ADDENDUM #3 TO THE BID & SPECIFICATIONS

February 10, 2023

**BID SCHEDULE
CLEAR CREEK INTERCEPTOR - SANITARY SEWER PHASE A**

1 TYPICAL PIPE/UTILITY CROSSING TRENCH DETAIL PAVED AREAS

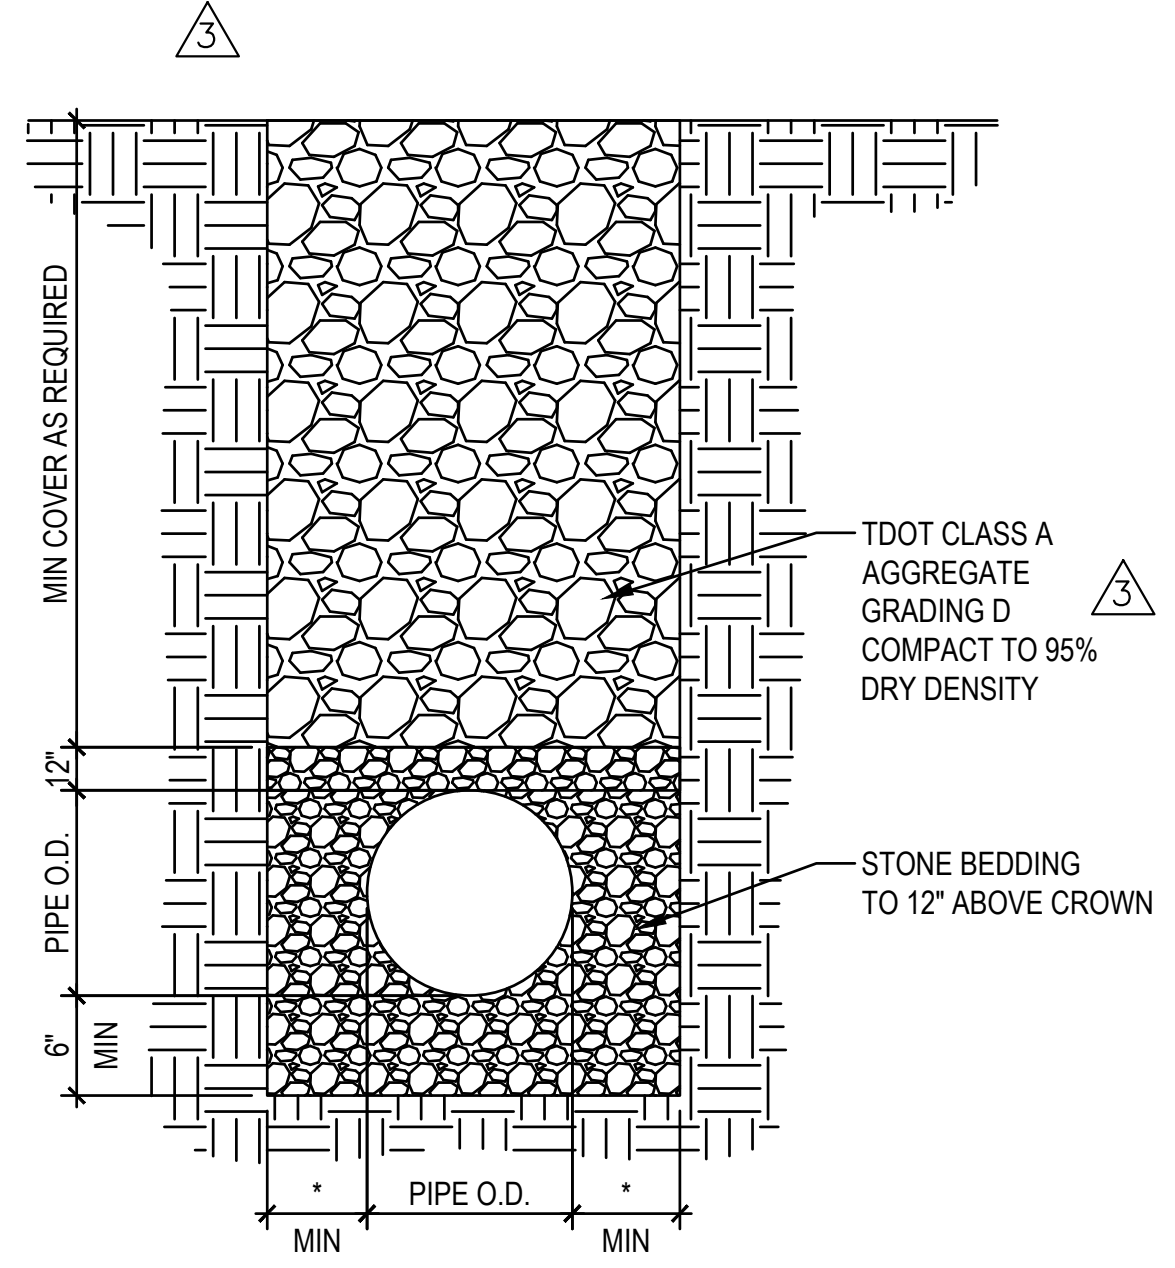
Replace Sheet C-501 with attached C-501. Changes include:

- Modifies Detail 1, Typical Pipe Utility Crossing Trench Detail Paved Areas to limit detail to trench only. It now - refers to paving detail on Sheet C-502.

REFER TO TYPICAL
PAVEMENT REPAIR
DETAIL SHEET C-502

DRAWING NO. C-502

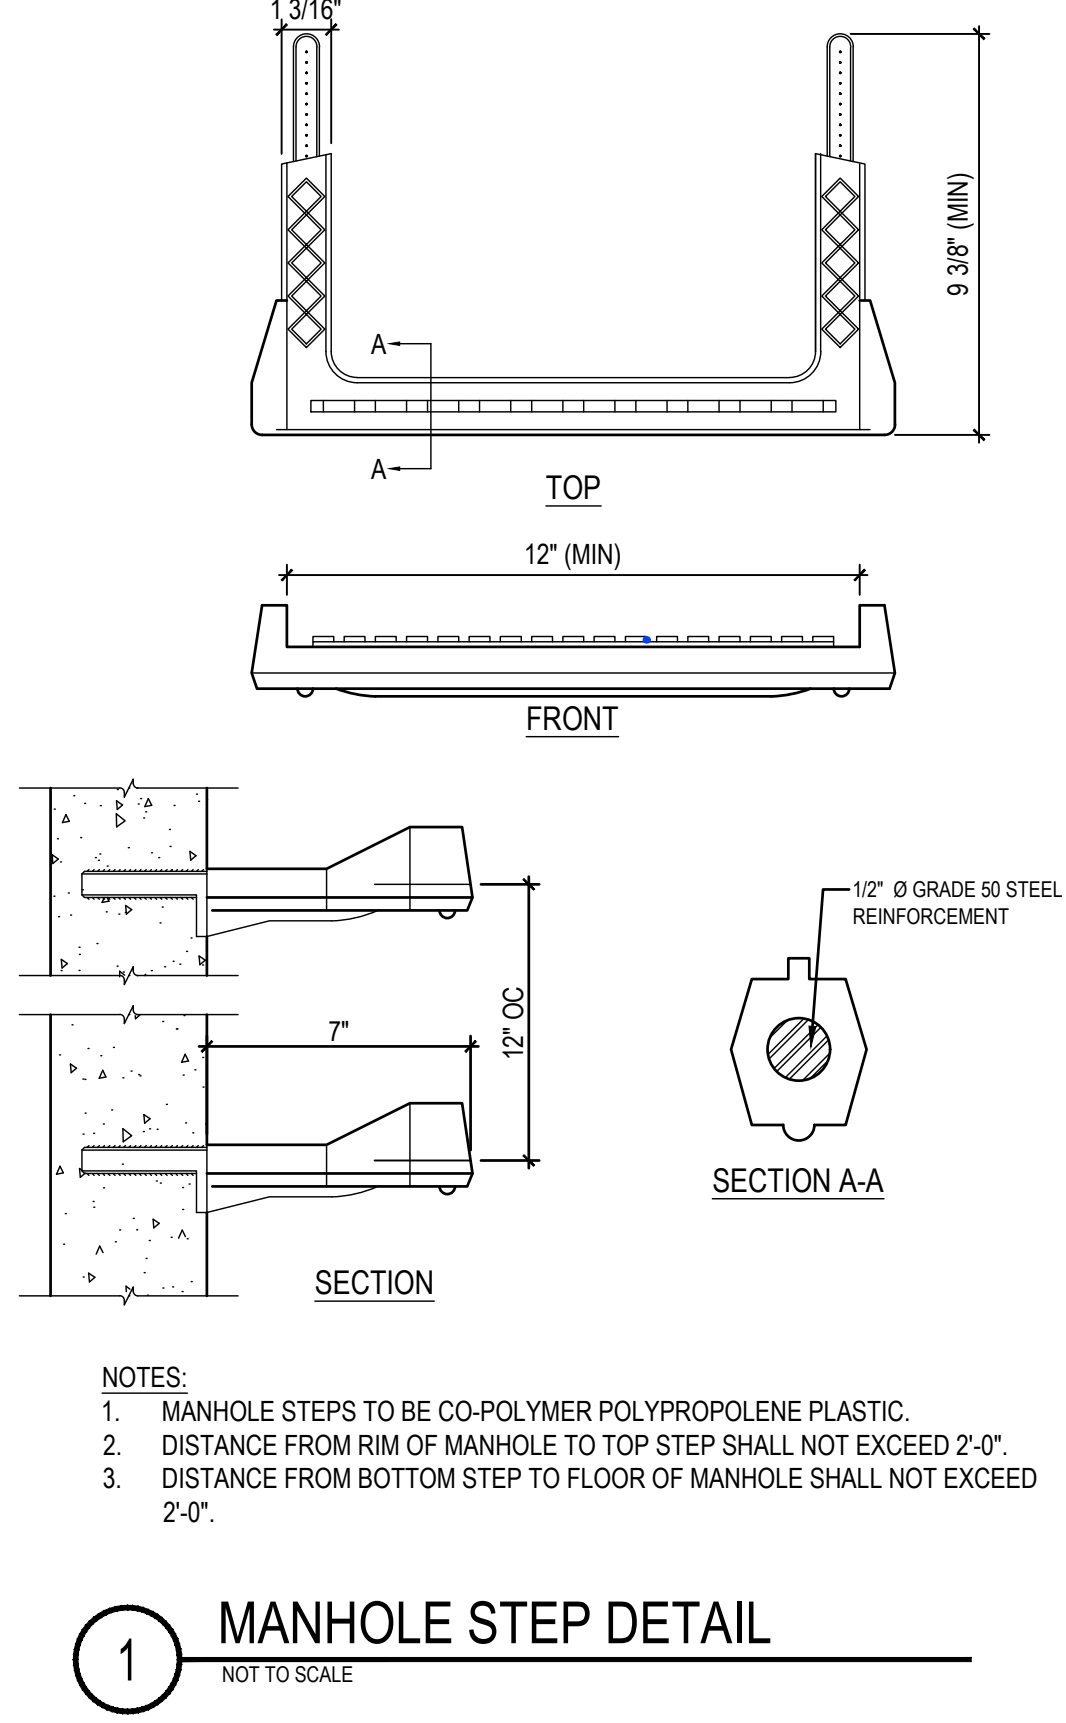
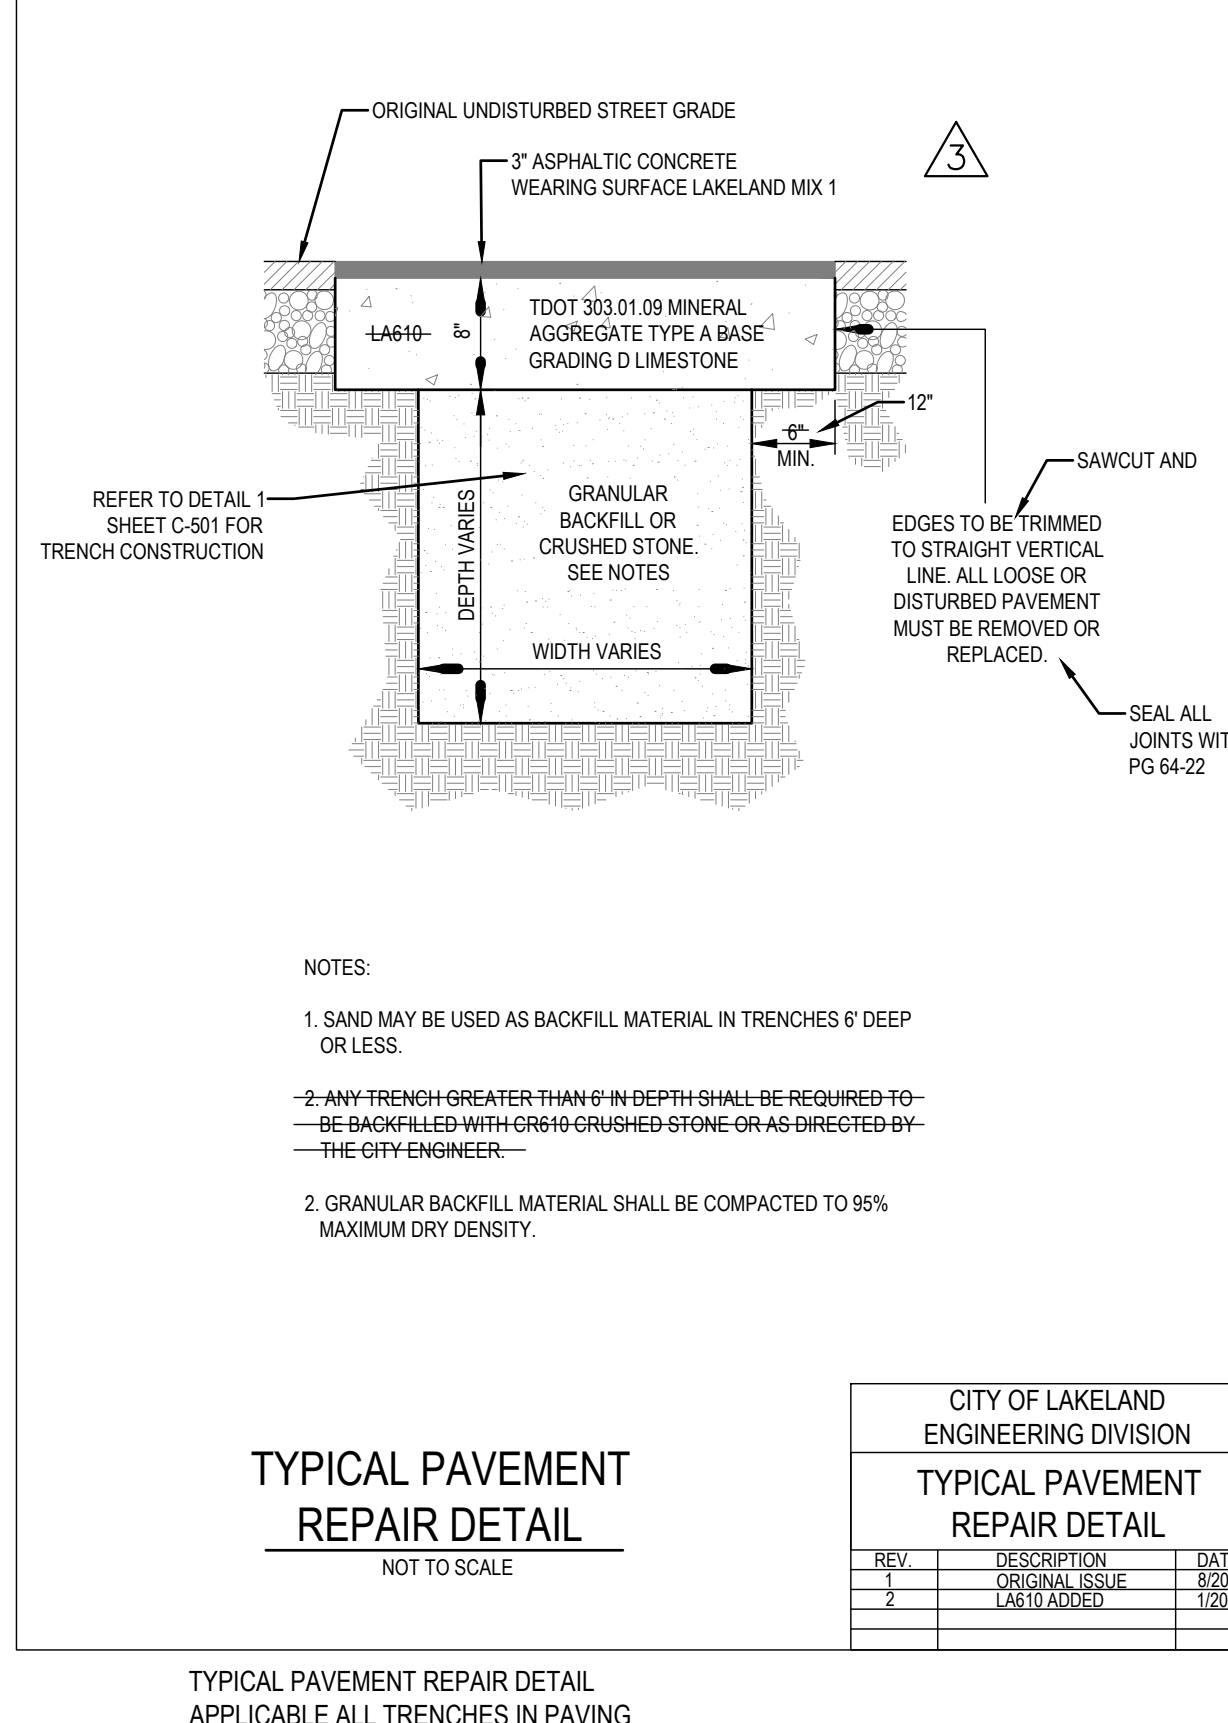
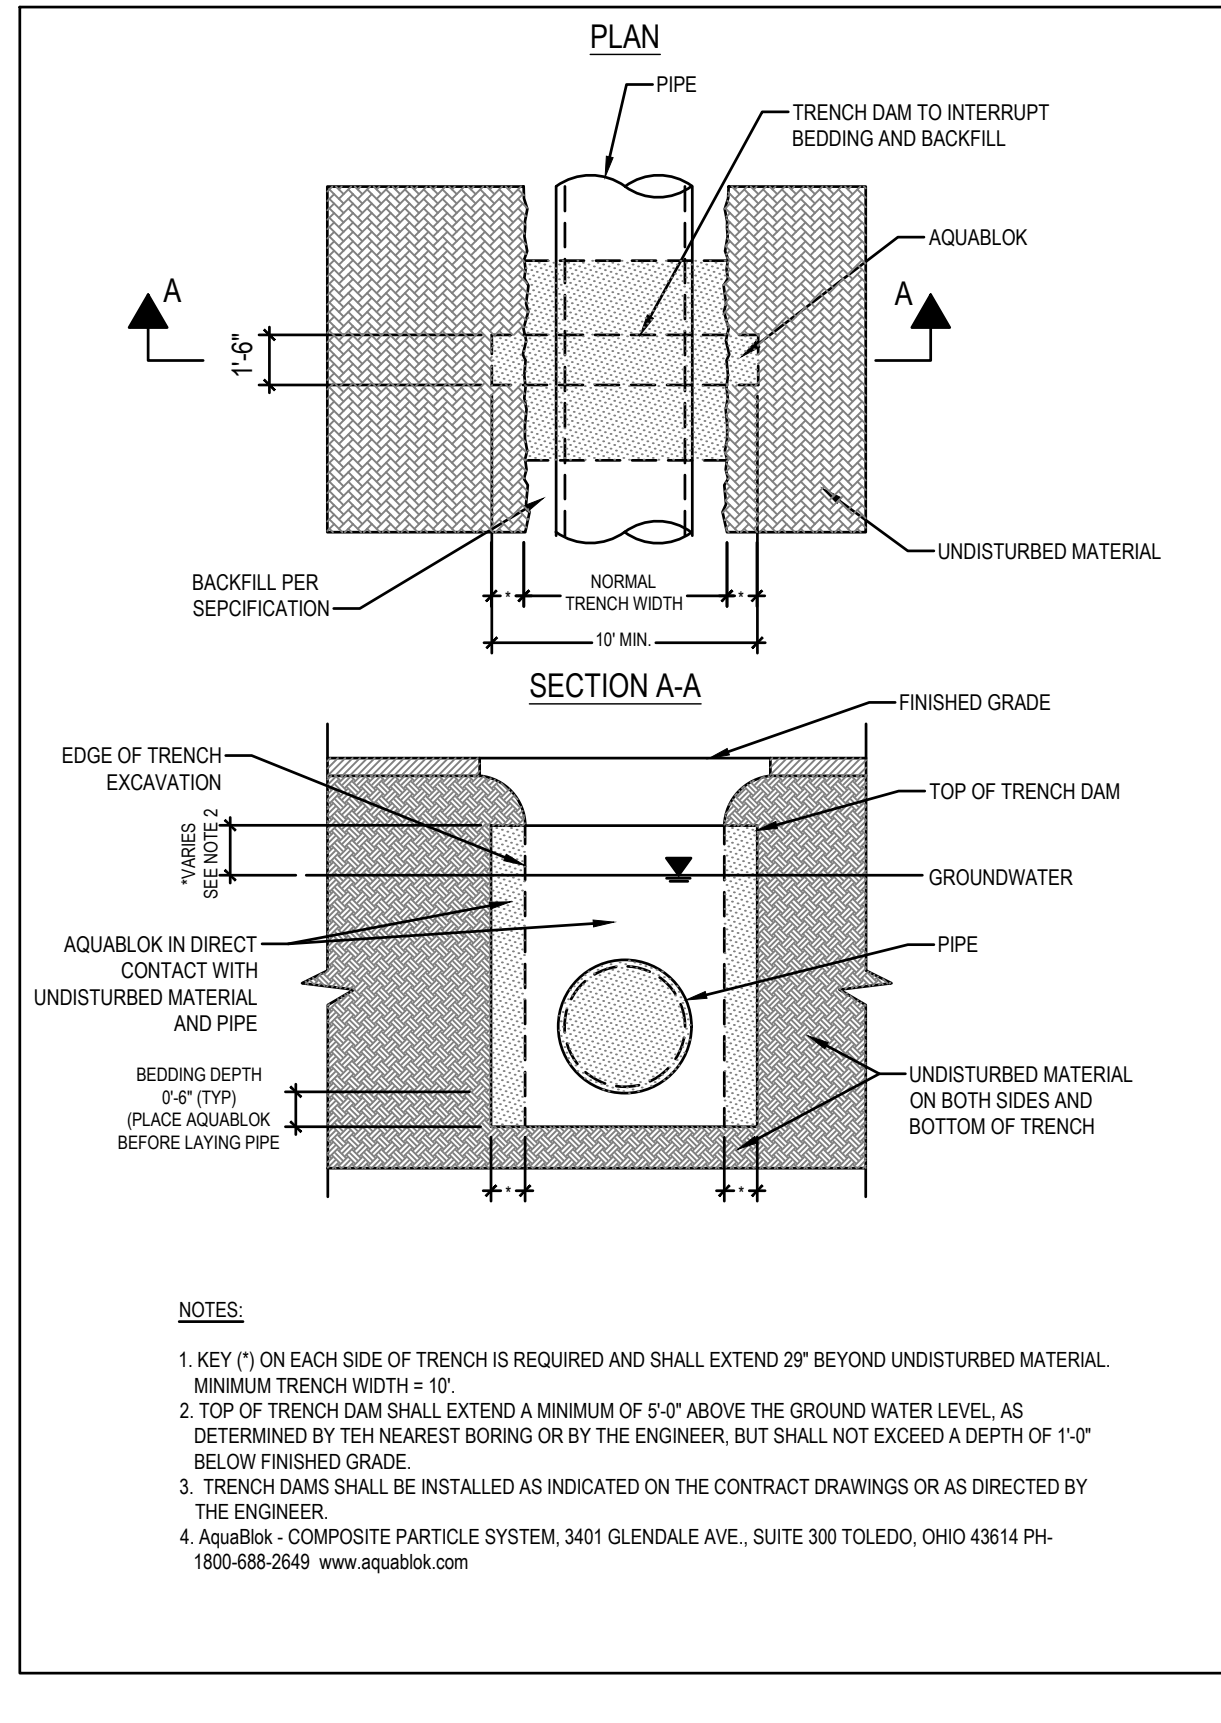
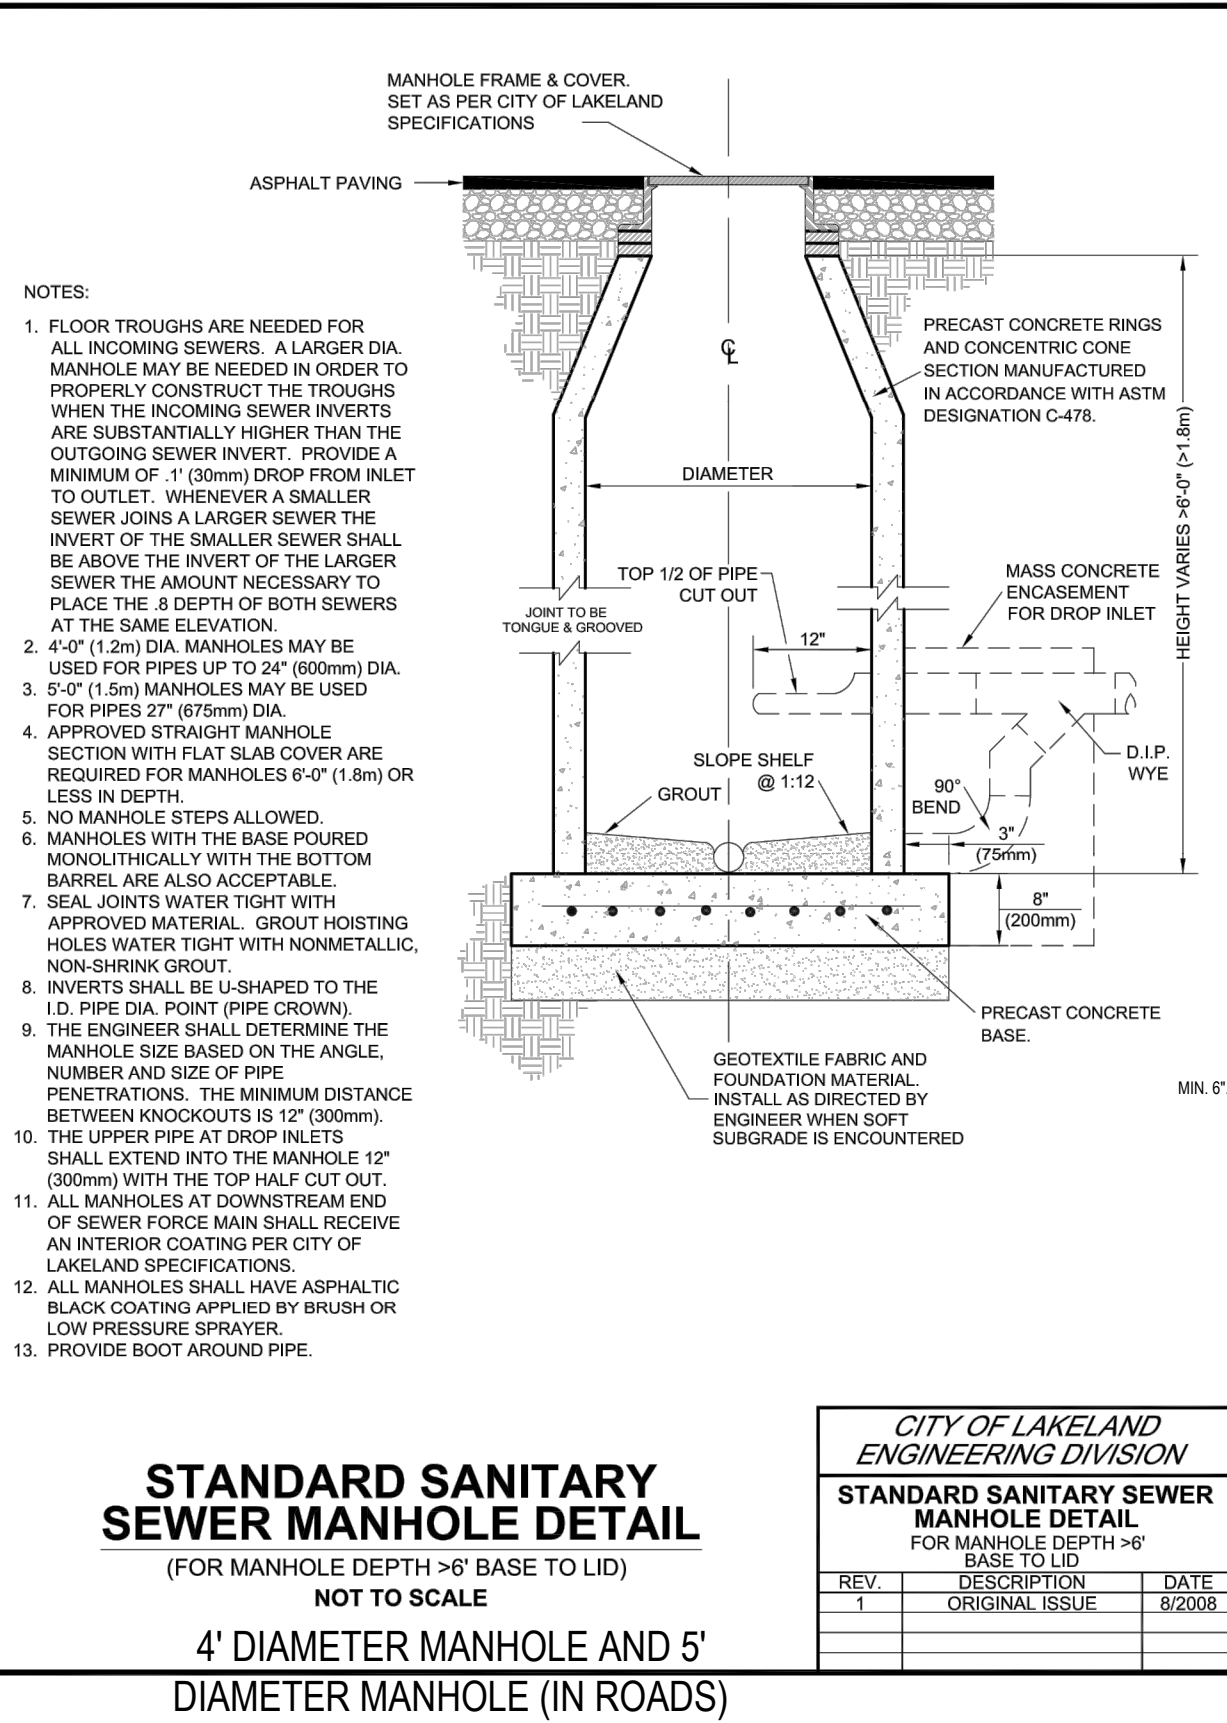
Replace Sheet C-502 with attached C-502. Changes include:

- Modifies City of Lakeland Standard Typical Pavement Repair Detail. Detail is applicable to all trenches requiring paving.
- Adds Note 11 to Detail 3 to list materials for gooseneck vent pipes.
